# Access Compliance Report

## Public Rights-of-Way (Curb Ramps)

Intersection ID: 10022294	Main Street: CAMBRIDGE_GREEN_DR	Cross Street: N/A	Location: W
ADA ID: 96955425A48B	Ramp Type: Perp	Initial Pass/Fail: Fail	Overall Compliance: No
Severity Score: 10			
Codes/Mitigation Info/Possible Solution		Field Measurements/Component Compliance

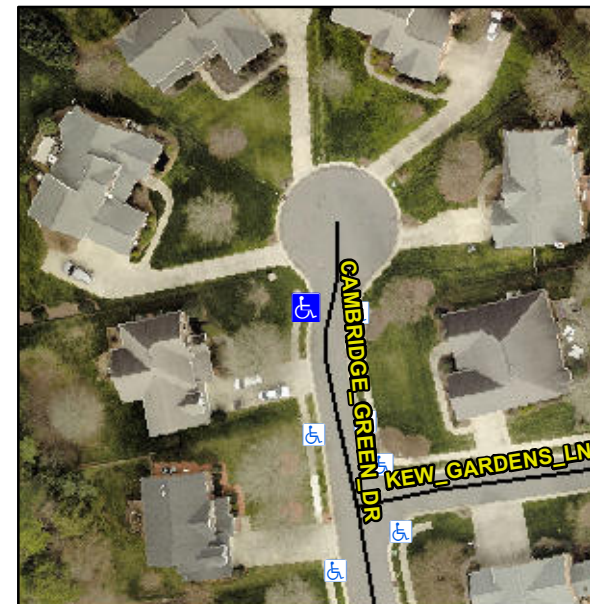
**Remove & Replace Entire Ramp.**

**Not Found, R304.5.1, R304.5.3**

Compliance	Description	Data	Compliance	Description	Data
N/A	Ramp Length (in)	47.0	Yes	Ramp Slope (%)	6.8
No	Ramp Width (in)	42.0	No	Ramp XSlope (%)	4.3
N/A	Flare Type LT	N/A	N/A	Flare Type RT	N/A
N/A	Flare Slope LT (%)	N/A	N/A	Flare Slope RT (%)	N/A
N/A	Flare Traversable LT?	N/A	N/A	Flare Traversable RT?	N/A
N/A	Landing Length (in)	N/A	N/A	DWS Provided?	N/A
N/A	Landing Width (in)	N/A	N/A	DWS Contrast?	N/A
N/A	Landing Slope (%)	N/A	N/A	DWS Length (in)	N/A
N/A	Landing X Slope (%)	N/A	N/A	DWS Full Width?	N/A
N/A	Landing Curb? (Y/N)	N/A	N/A	DWS Offset (in)	N/A
N/A	Shared Landing?	N/A			
N/A	Gutter Ponding?	N/A	N/A	Gutter Slope (%)	N/A
N/A	Gutter Lip Ht (in)	N/A	N/A	Gutter X Slope (%)	N/A
N/A	Painted X Walk1?	No	N/A	Painted X Walk2?	N/A
	X Walk 1 Direction	To E		X Walk 2 Direction	N/A
N/A	X Walk 1 Width (in)	N/A	N/A	X Walk 2 Width (in)	N/A
	X Walk 1 Slope (%)	5.5		X Walk 2 Slope (%)	N/A
	X Walk 1 X Slope (%)	3.6		X Walk 2 X Slope (%)	N/A
